ADDENDUM NO. 04

Baggage Screening Improvements – Phase 2A
[Loading Dock Reconfiguration, Sheriff’s Checkpoint Removal, Jetway Installation
(Gate 30, 46, 47), IAB Airside Trash Remodel, North Checkpoint Relocation]

PROJECT NO. A044-09002

DATE OF ADDENDUM: June 16, 2011

D101A

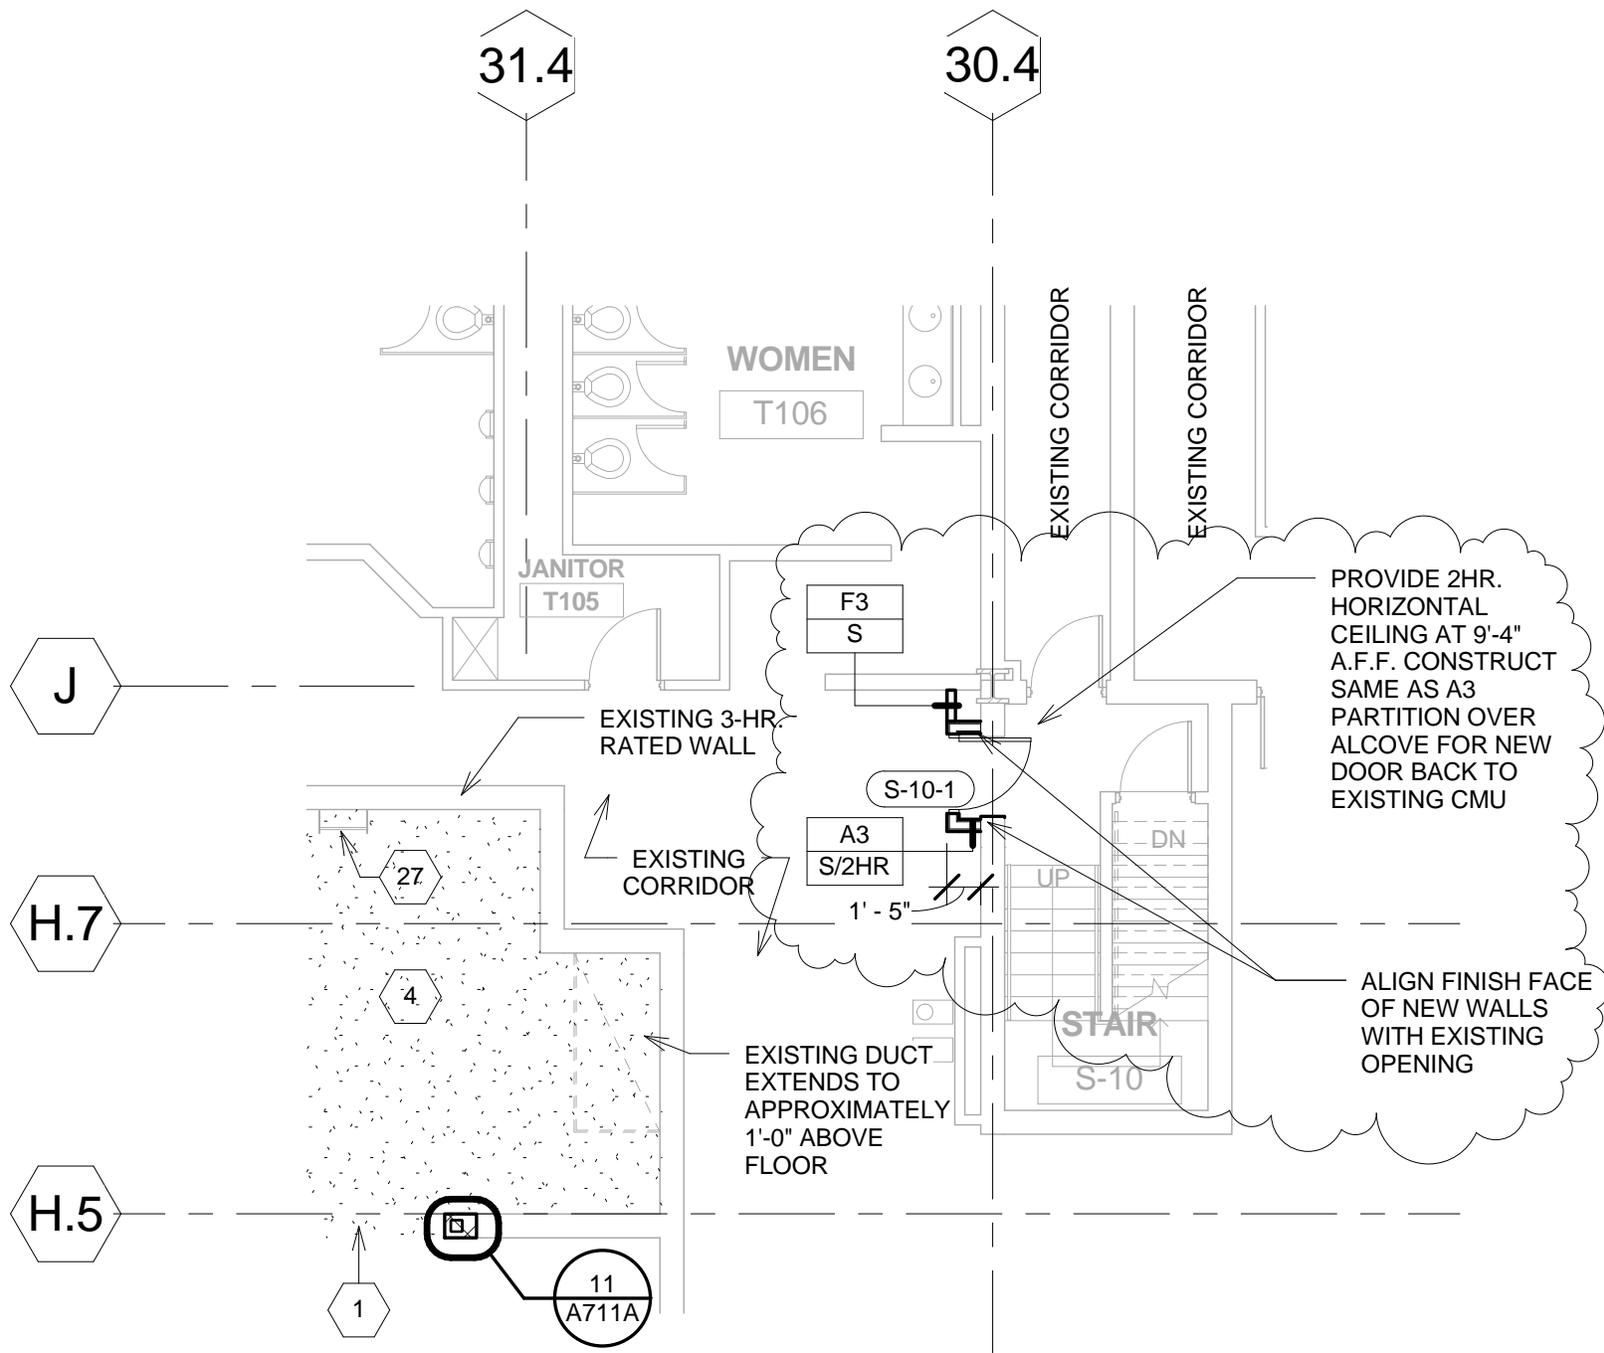
D101A: Detail 2 Grade Level Demolition Plan - North – ADD the removal of an existing door and portion of wall, and surrounding finishes, at the north wall of existing Stair S-10. (See the attached revision drawing D101A.)

A101A

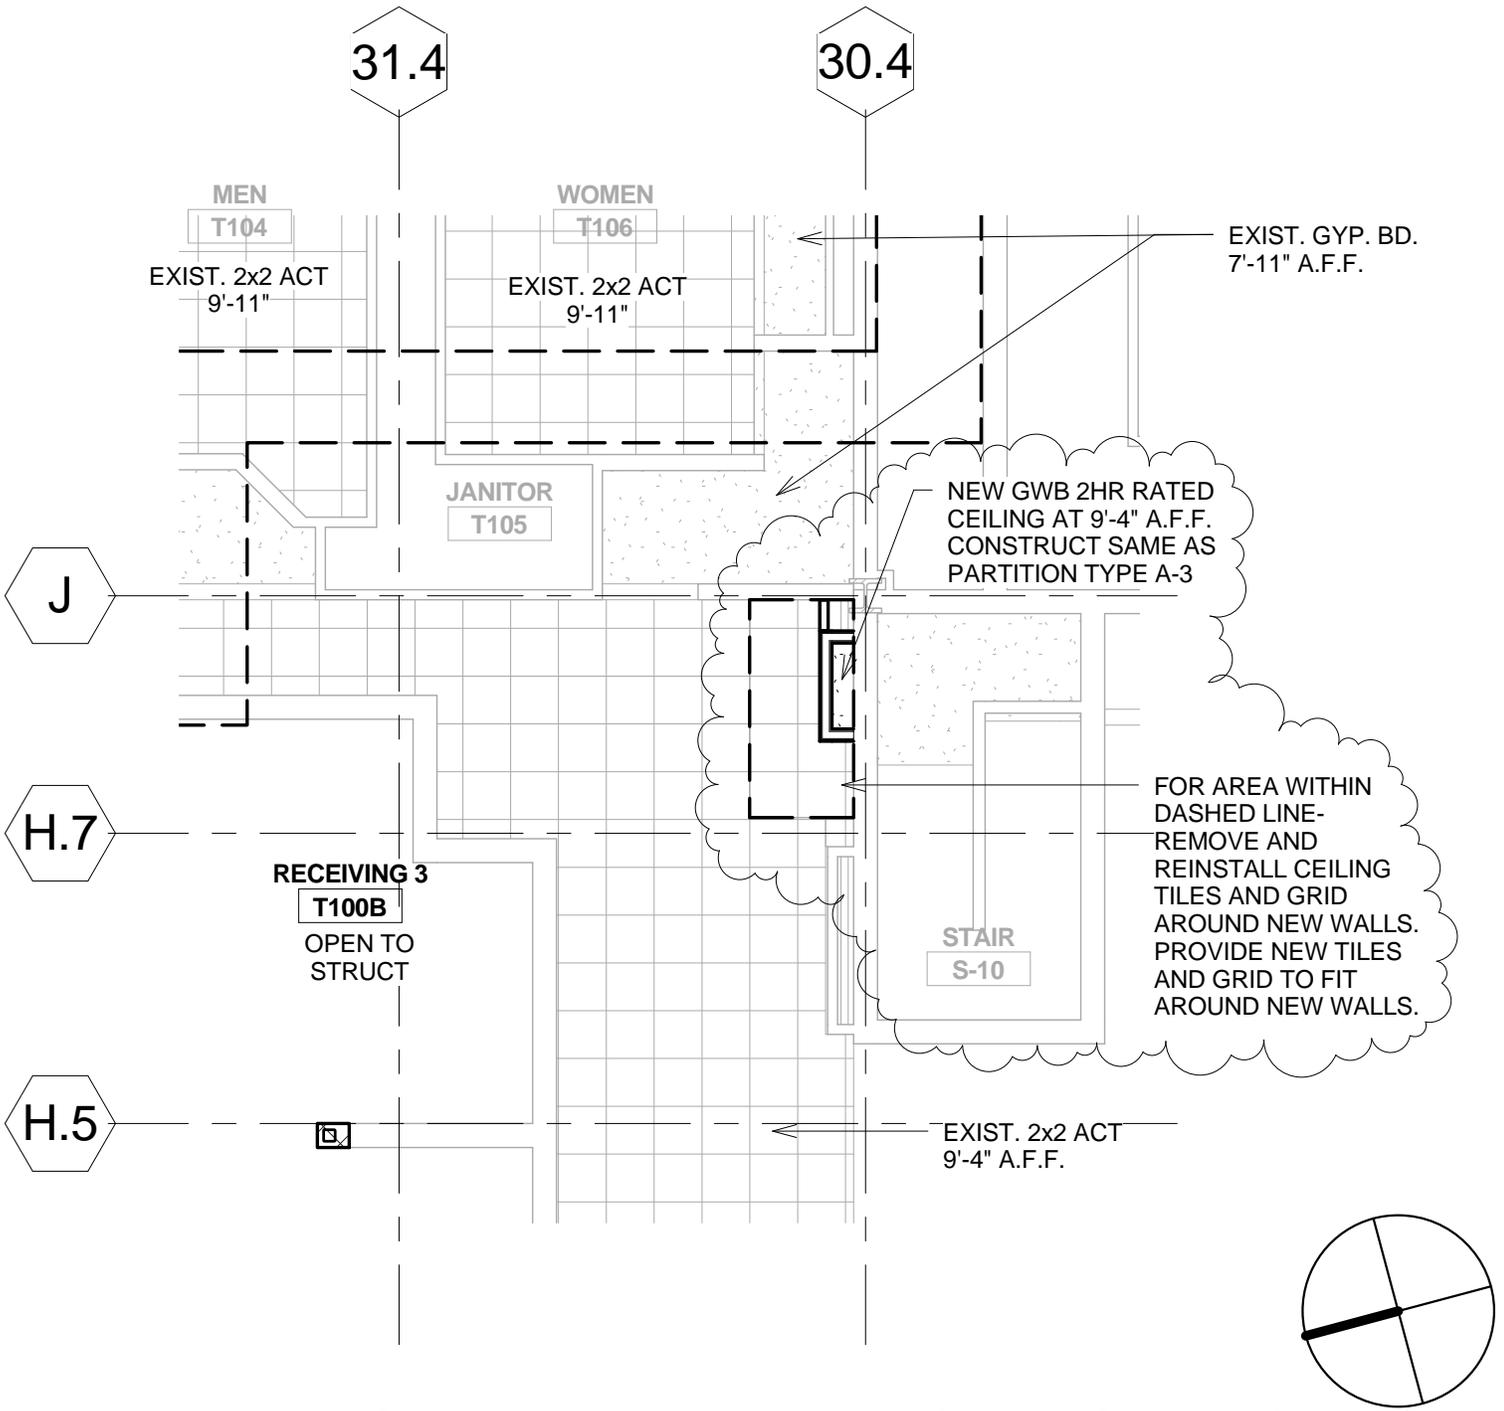
A101A: Detail 1 Partial Grade Level Plan – North Loading Docks – ADD new walls and door at the north wall of existing Stair S-10. (See the attached revision drawing A101A).

ED101A

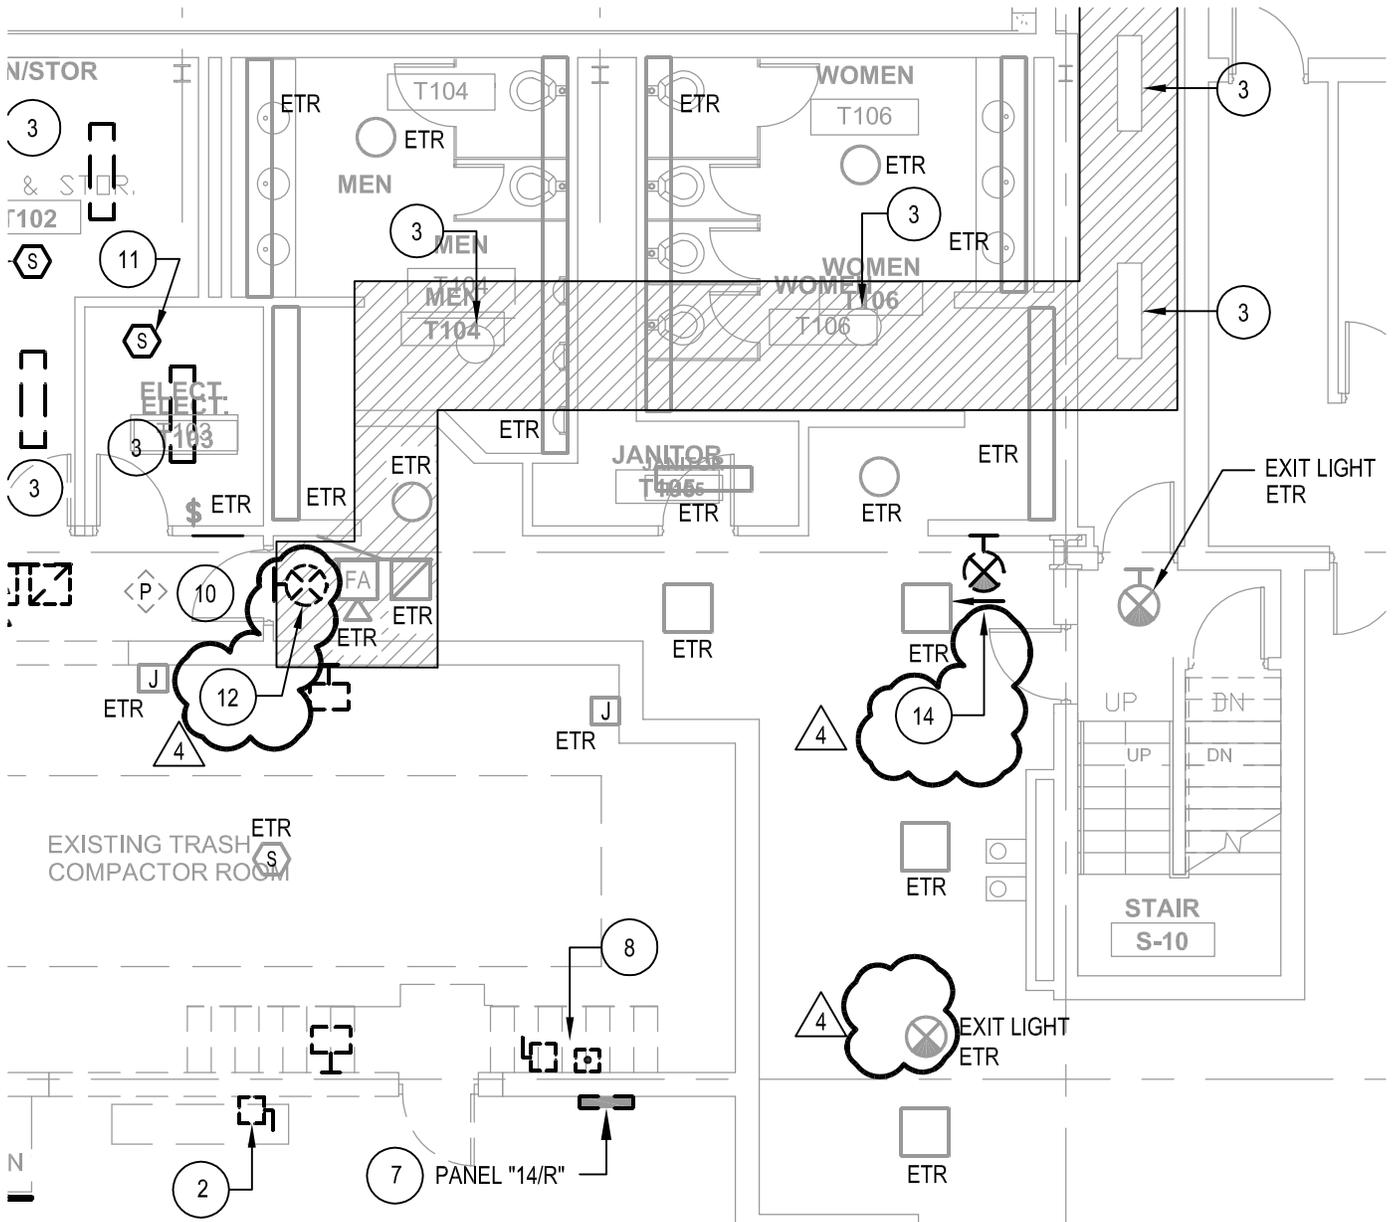
ED101A: ADD reference to note **12** for exit sign at door to corridor. DELETE reference to key note **12** from exit sign in corridor. ADD reference to key note **14** by exit sign outside of restroom. Revised Key note **12** to read as follows:

ADD key note **14** to read as follows:

DISCONNECT EXISTING EXIT SIGN. RELOCATE TO STAIR S-10 AS SHOWN ON E301A.

DISCONNECT AND REMOVE EXISTING EXIT SIGN. RETAIN CONDUIT AND WIRING AND EXTEND TO RELOCATED EXIT LIGHT AS SHOWN ON E301A.

E301A

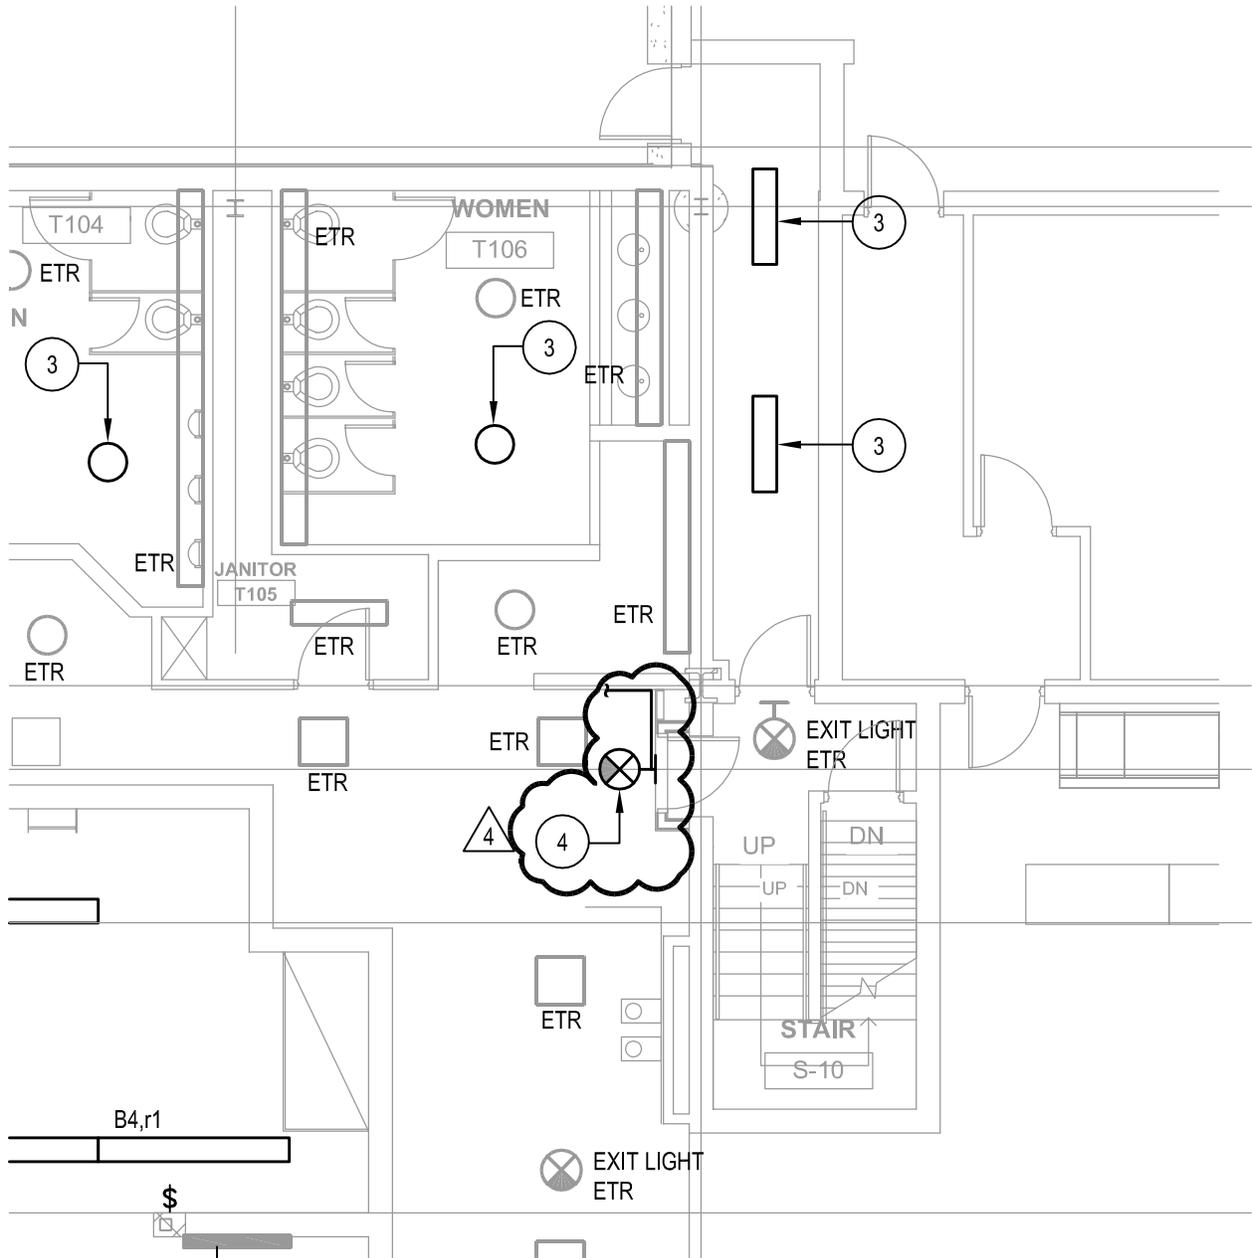
E301A: ADD relocated exit sign at entrance to stair S-10. ADD reference to note **4** next to exit sign. ADD note **4** to sheet note to read as follows:

RELOCATED EXIT SIGN. EXTEND EXISTING CONDUIT AND WIRING TO NEW LOCATION.
